April 27, 2021

**NOTICE OF ADDENDUM
ADDENDUM NO. 2
CONTRACT NO. 8576**

**NORTH BROOKS STREET, FAHRENBROOK COURT AND COLLEGE COURT RESURFACING
ASSESSMENT DISTRICT - 2021**

SHEET
D-3

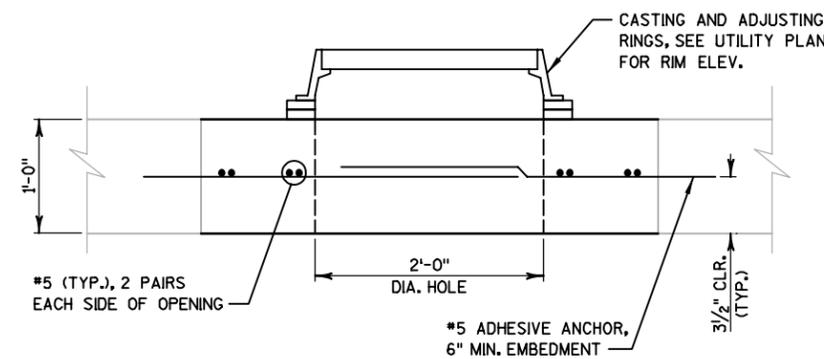
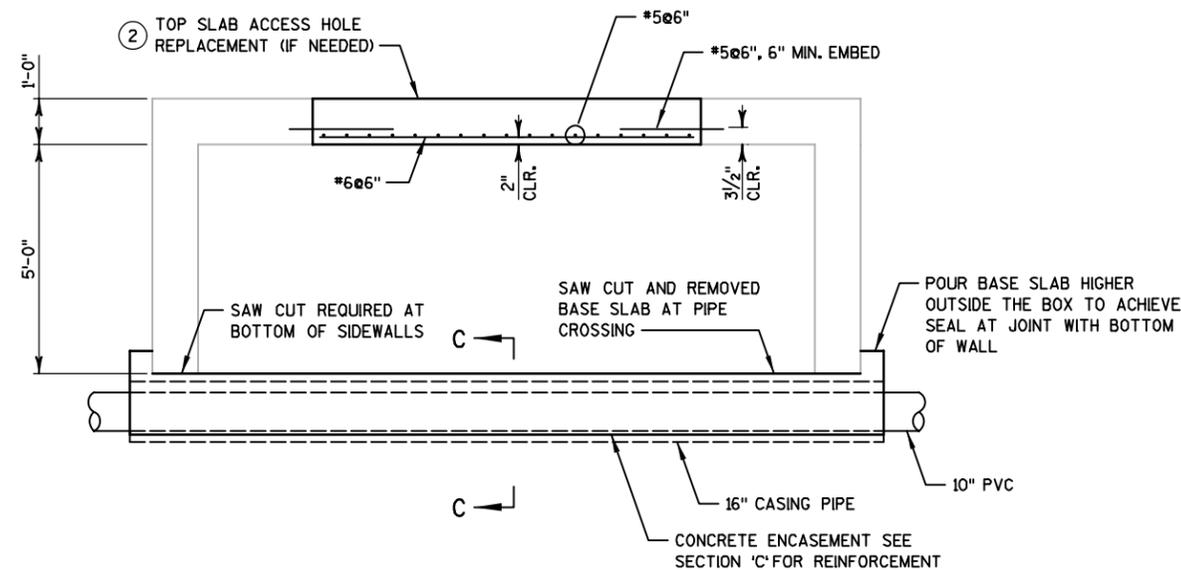
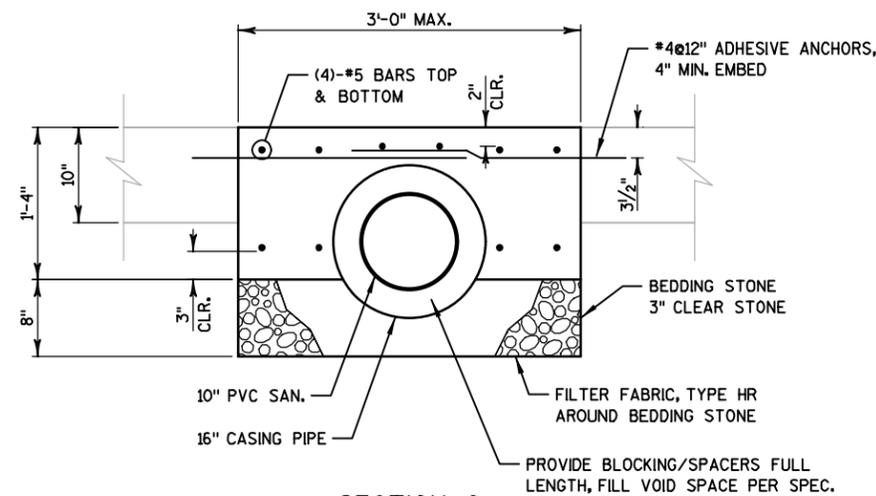
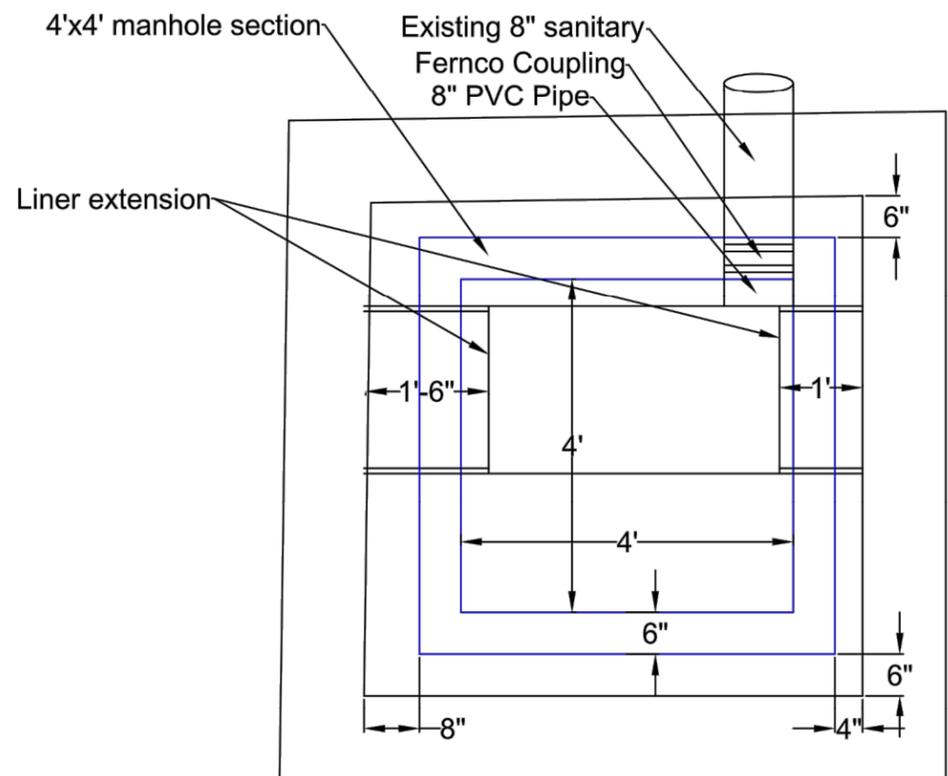
Add attached page D-3: Reinforced Concrete Box Culvert Modifications for sanitary sewer box crossing and top slab replacement.

NOTE:
RCBC ACCESS HOLE IS NOT REQUIRED. DETAIL IS PROVIDED FOR USE AT CONTRACTOR'S OPTION. SIZE AND LOCATION OF ACCESS TO BE DETERMINED BY CONTRACTOR.

- ① THE OUTER 3'-6" OF THE TOP SLAB SHALL NOT BE REMOVED.
- ② ACCESS HOLE DIMENSIONS SHALL BE DETERMINED BY CONTRACTOR FOLLOWING THE CRITERIA PROVIDED ON THIS SHEET. CONTRACTOR SHALL SUBMIT REQUESTS FOR A DIFFERENT SIZE OF OPENING TO ENGINEER FOR REVIEW.

13180						
D-4

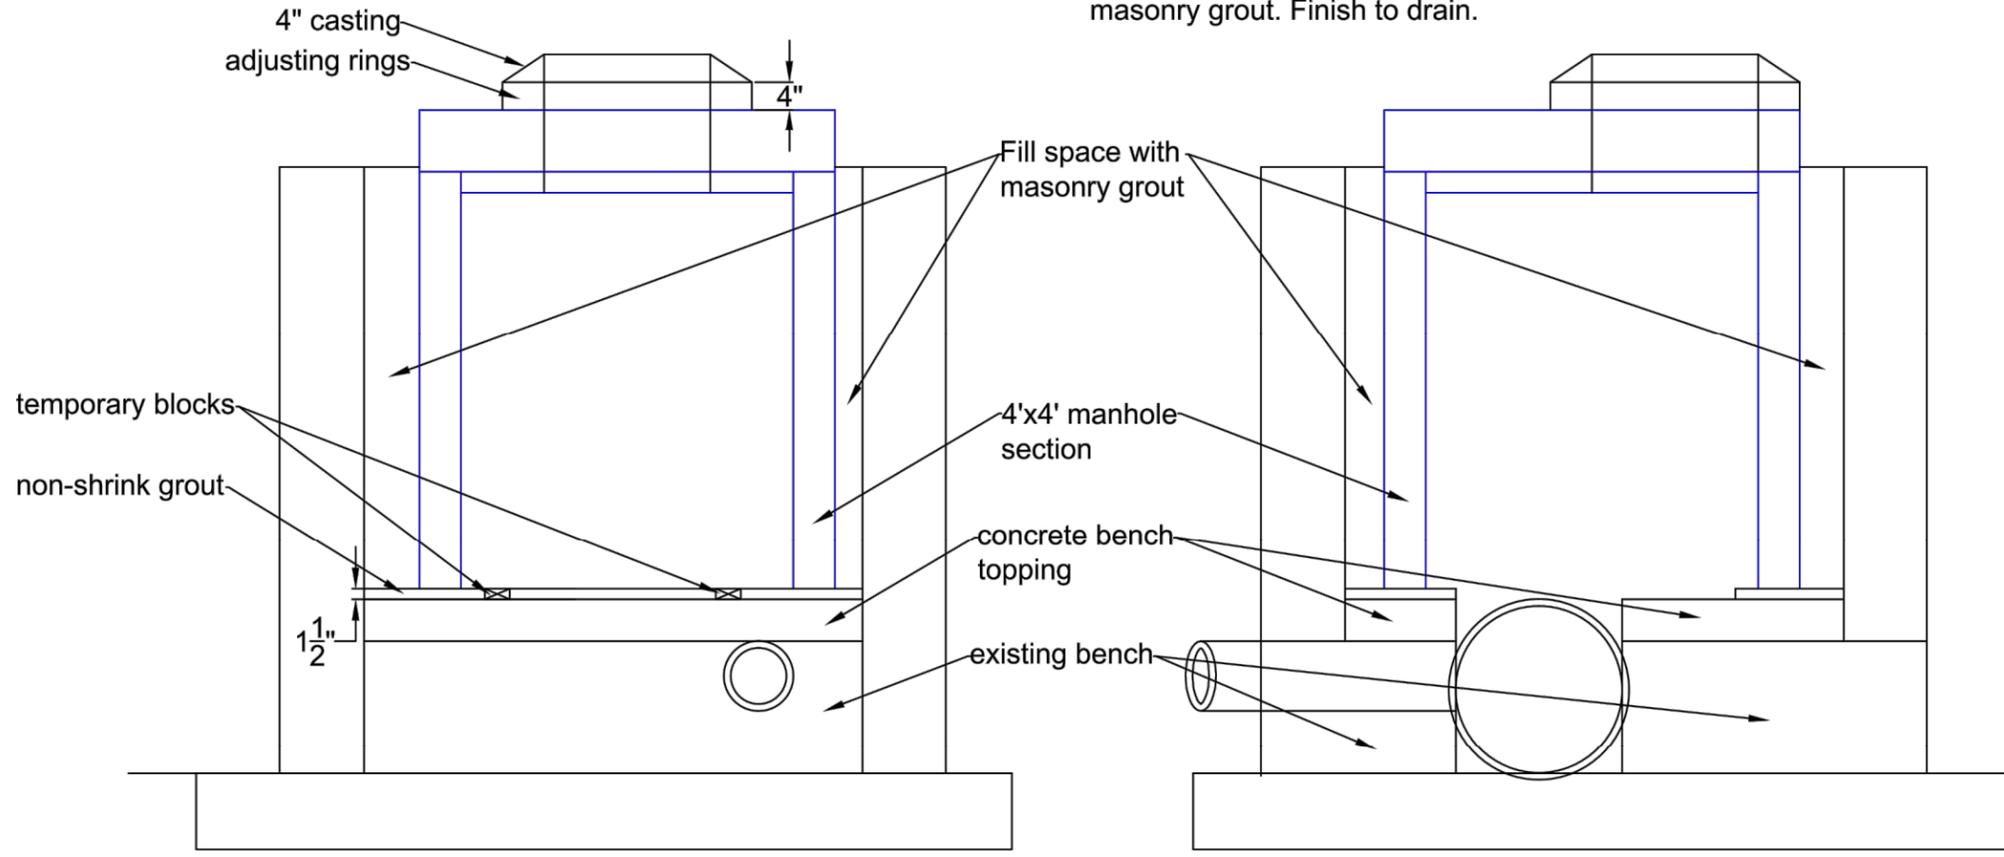
Add attached page D-4: Existing MMSD sanitary sewer structure detail for Contractor reference.

Manhole MH02-007 Repairs
 Extend liner into manhole to limits shown. Power wash existing bench. Remove loose concrete.
 Extend existing 8" sanitary with standard fernco and PVC pipe. Finish flush to channel wall.
 Form for new bench topping flush to channel walls. Place 4000 psi concrete and finish level to top of liner.
 Set 4'x4' manhole section with temporary blocks on manhole bench. Position as shown.
 Form and place 1-1/2" flowable non-shrink grout at manhole section base as shown. After grout has set, remove temporary blocks and grout pack voids.
 Fill annular space between new manhole section walls and old manhole walls with masonry grout. Finish to drain.

13180	ADDENDUM 2	DATE	BY	U-2
13180	REVISION	Date: 4/27/2021 11:28 AM	Scale: #####	
13180 SEWER UTILITY PLAN & PROFILE - N BROOKS ST N BROOKS ST, FAHRENBROOK CT & COLLEGE CT RES ASMNT DIST-2021 MADISON, WI CONTRACT NO.: 8576 M:\DESIGN\Projects\13180\CAD\SEWERS\13180SEWERS_LAYOUT.dwg				
13180 U-2

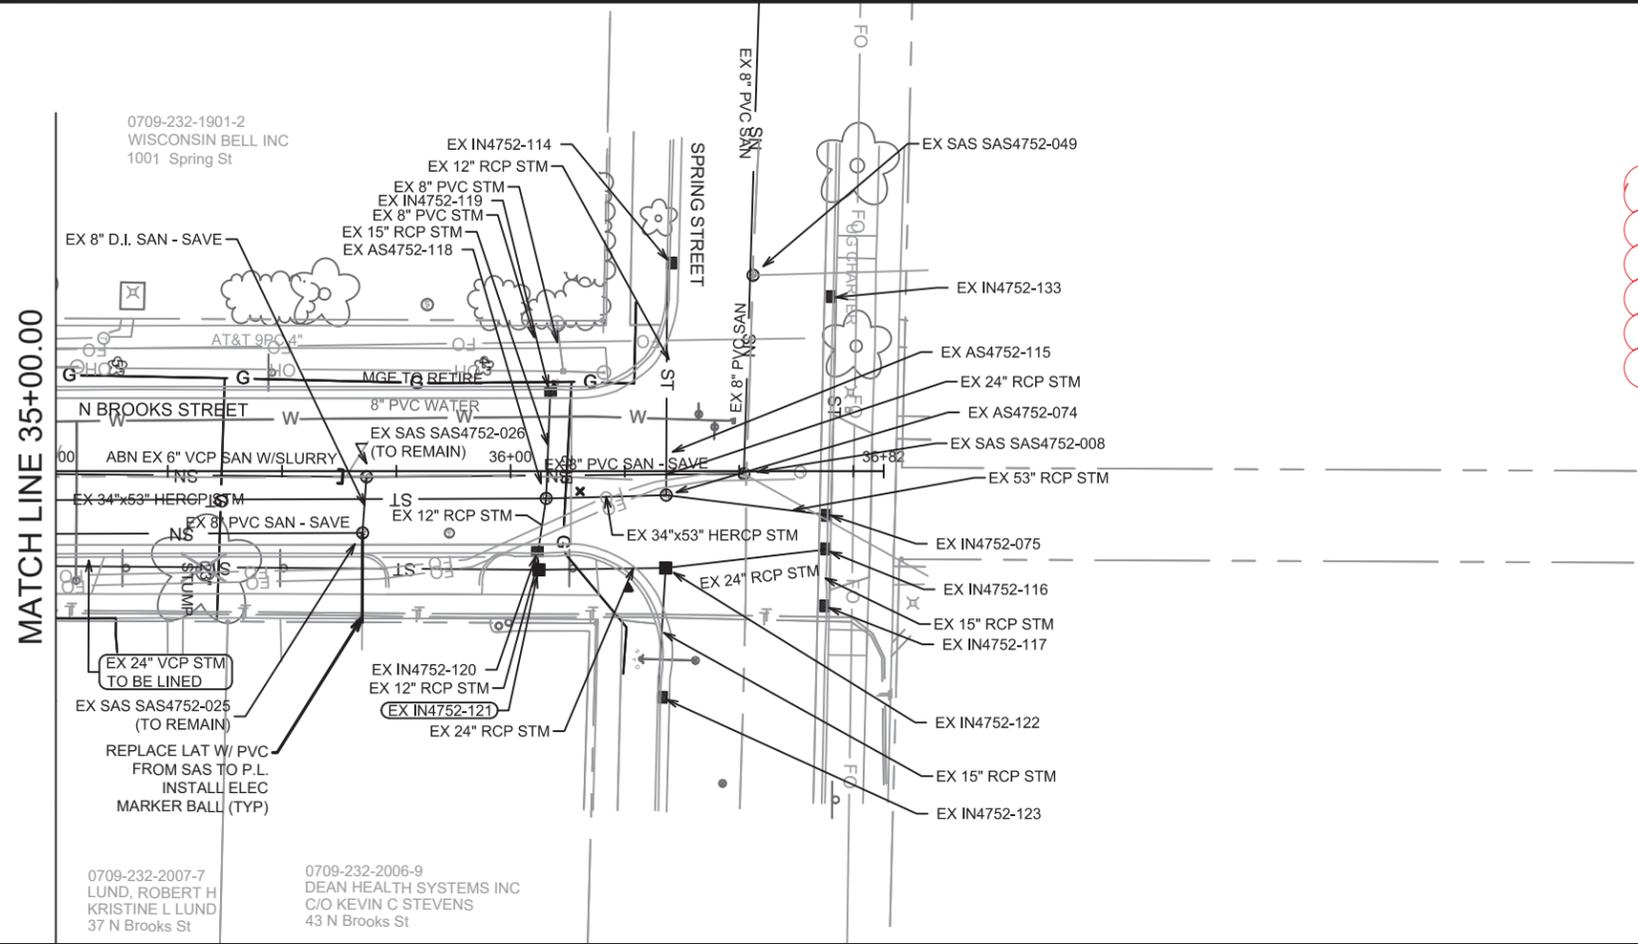
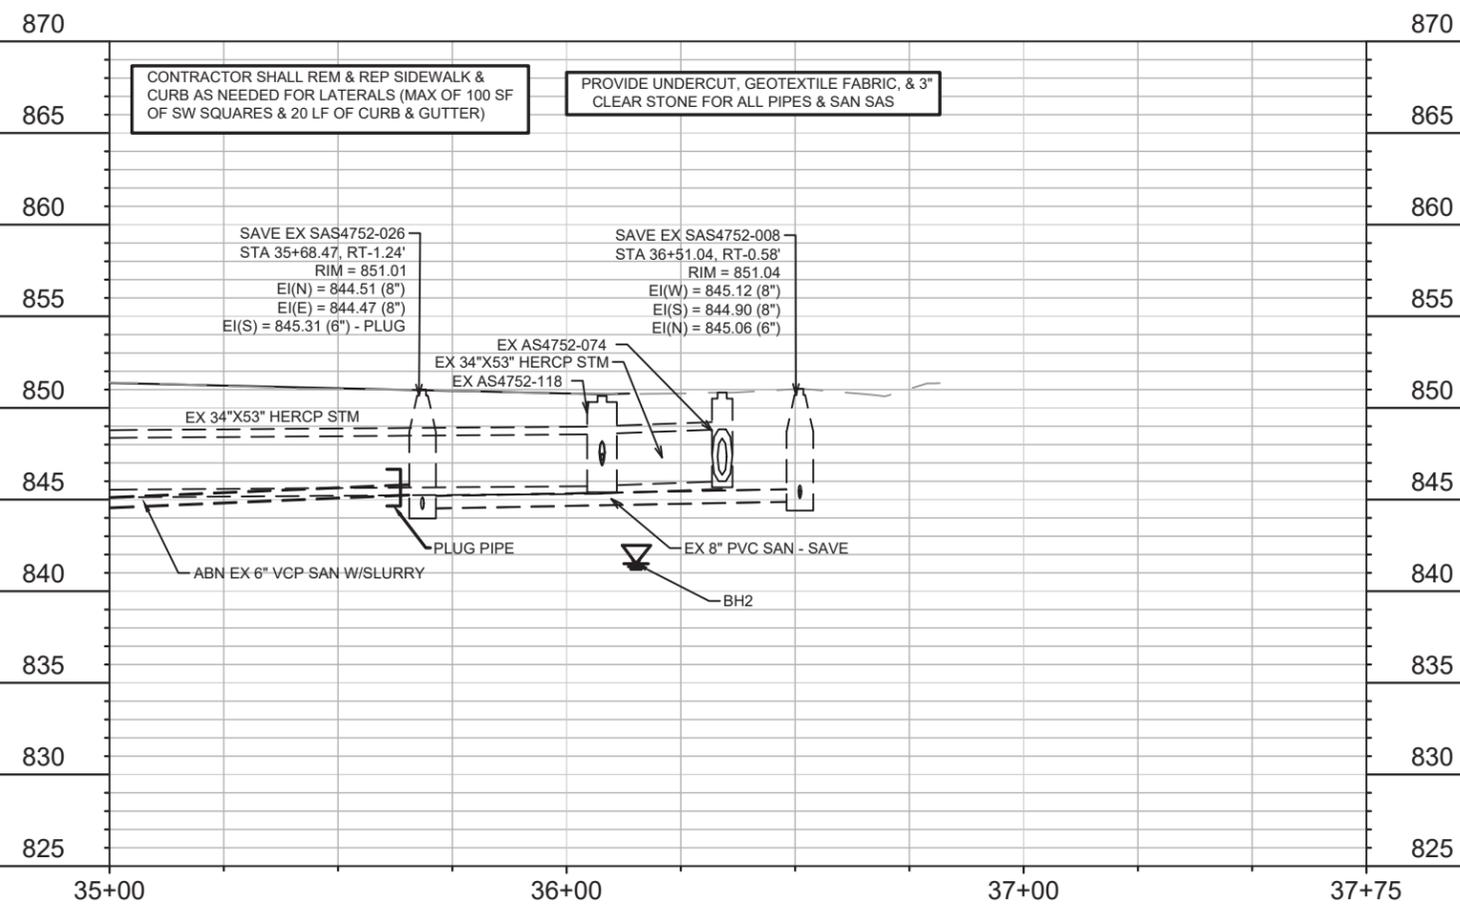
Remove and replace attached page U-1 to U-8: Updated plans with revised sanitary sewer layout.

ALL PROPOSED
 SANITARY HAS BEEN
 CHANGED FOR
 ADDENDUM 2

CONTRACTOR SHALL REM & REP SIDEWALK & CURB AS NEEDED FOR LATERALS (MAX OF 100 SF OF SW SQUARES & 20 LF OF CURB & GUTTER)

PROVIDE UNDERCUT, GEOTEXTILE FABRIC, & 3" CLEAR STONE FOR ALL PIPES & SAN SAS
